Dr Lucy Chadwick, 84 Connaught Street, Phibsborough, Dublin 7, D07 YV02

Re: CPO: Blanchardstown Bus Corridor, Case Reference: KA29N.313961

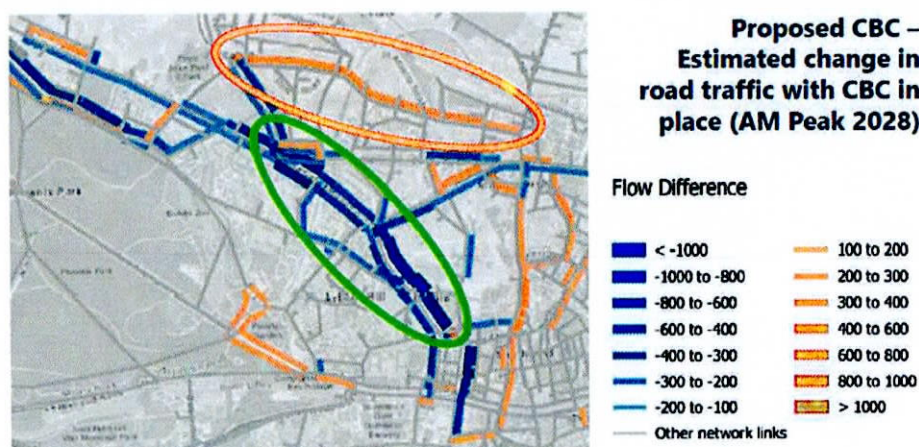
There are three road restriction changes proposed in the CPO application for the Blanchardstown Bus Corridor, none of which were set out in any of the proposed designs issued for public consultation since the Bus Connects project commenced in 2018.

The final preferred route was the result of three separate and rigorous stages of consultation since 2018 and yet none of the three proposed restrictions appeared in the [final preferred route](#) publication dated March 2022.

A number of changes were negotiated at a local level with residents' groups, in particular **Annamoe Road and Annamoe Terrace** (ref. BI) residents and their efforts to ensure their road does not become a "rat run," arising from the displaced traffic from the Old Cabra Road has meant significant changes to the original proposal which has dire consequences for our area. It is not clear why one resident's group would be successful in their endeavours to engage with the NTA to the severe detriment of another area such as mine.

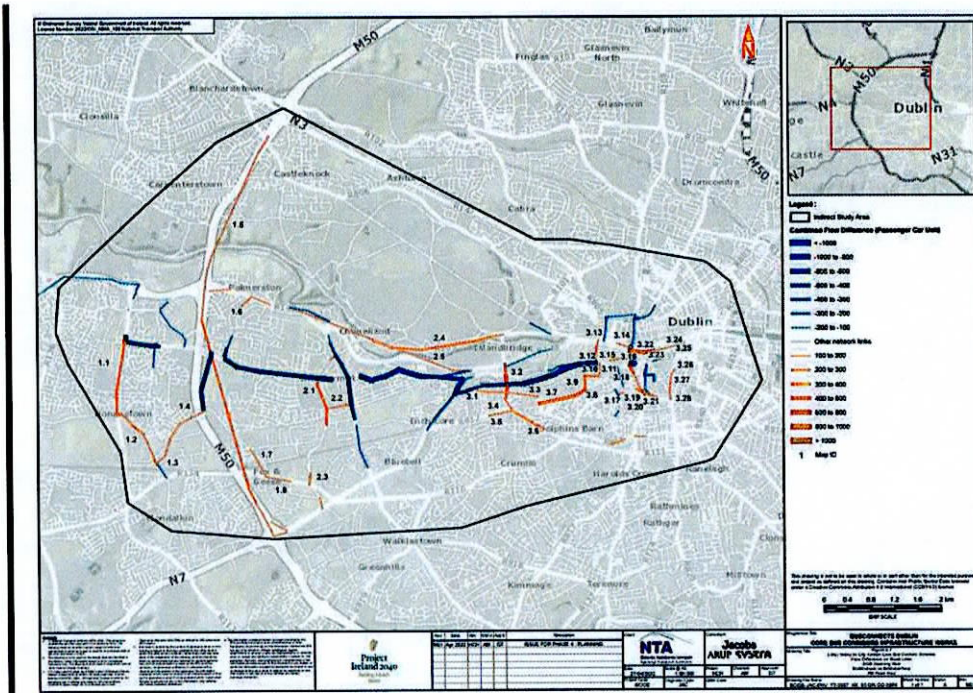
- An 80% increase in hourly traffic flows at the junction of Connaught Street and Shandon Crescent,
- A 55% increase in hourly traffic flows at the junction of Fassaugh Ave and Dingle Road,
- A 64% increase in hourly traffic flows at the junction of Fassaugh Ave and Bannow Road.

Each is described as having "not significant" effect and "negligible" impact. I can tell you as a resident of Connaught Street there is no way that changes of this nature can be considered "not significant" and "negligible" in their impacts on our abilities to go about our daily lives and live in a safe environment!

Furthermore, there is an estimated 70% increase in peak hourly traffic flows at the junction of Connaught Street and St Peter's Road. This was described as being a "low impact" with "moderate" effect. It appears that only areas that are forecast to experience increases in traffic volume to beyond 85% of road capacity are classified as having any impact at all.
